Please upload onto Ocella the email below and the attached revised plans and amended Flood Risk Assessment from the **applicant's drainage engineers** for planning application **A/76/20/PL** relating to Dappers Lane, Angmering.

Subject: RE: Dappers Lane A/76/20/PL

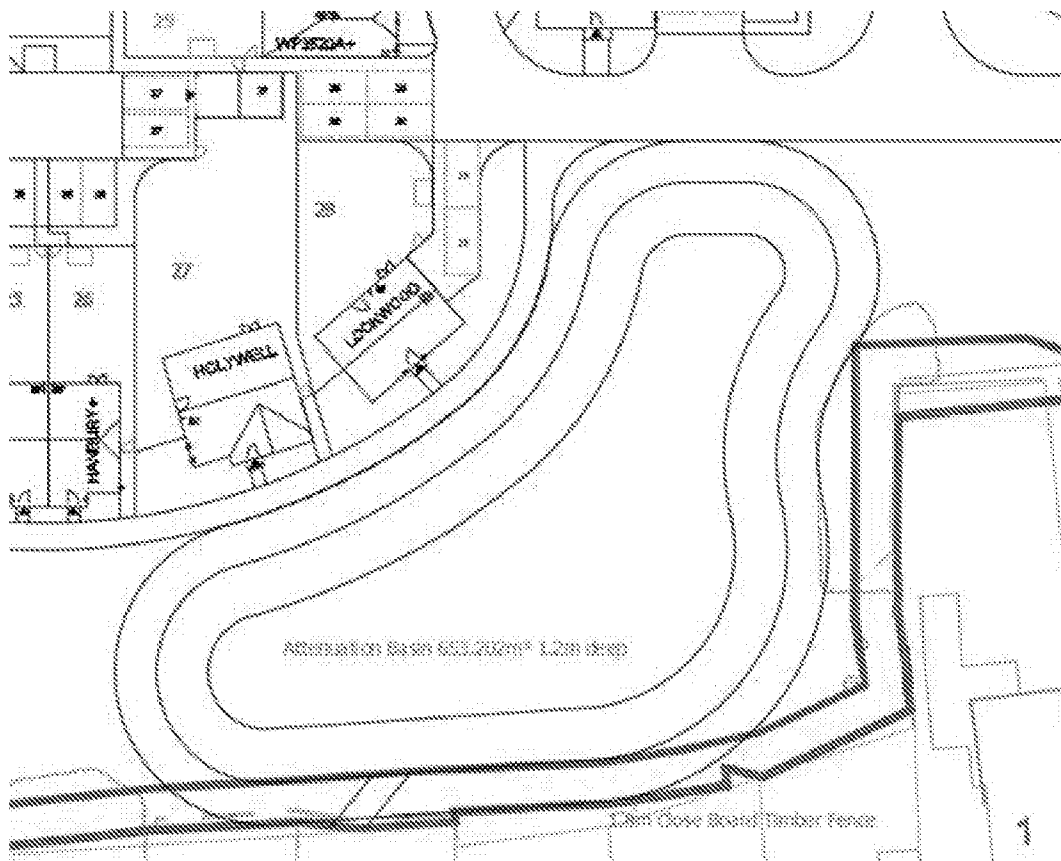
2. Cross sections of attenuation basin, detailing offset of basin to surrounding features, including adjacent ordinary watercourse. An unobstructed 3m buffer should be provided around the attenuation basin. There is a buffer around the pond of at least 3.00m, with the exception of to the south of the pond where it is slightly reduced owing to the re-grading works associated with the watercourse. This has not been detailed out at present, and is a point for detailed design. It is demonstrated, however, that the pond can be maintained with the buffer that is provided in all other areas. *See comment to point 5 below. The screen shot below has been provided by Rob with the following comment; 'The outer 'circle' shows the 3 metre offset at the top of the bank (of the pond). This coincides with the 3 metre maintenance strip for the culvert along the southern edge.'*

At present (i.e. as existing, pre-development) a section of the southern boundary is culverted. We have proposed to reinstate as open-ditch for the full extent of the southern boundary up to the outfall point (the south-west corner), offering betterment and reducing maintenance issues – i.e. potential blockage situations. If the culverted section is reinstated as open-ditch, and the 3.00m buffer measured from the top of the bank overlaps/conflicts so to speak with the 3.00m buffer associated with the pond, the 3.00m can be provided in both instances by slight adjustment to the pond footprint – extending to the west where there is ample space available in order to compensate for the loss of area if we 'skinny' the pond up to the south (allowing/providing for the requirement easement).
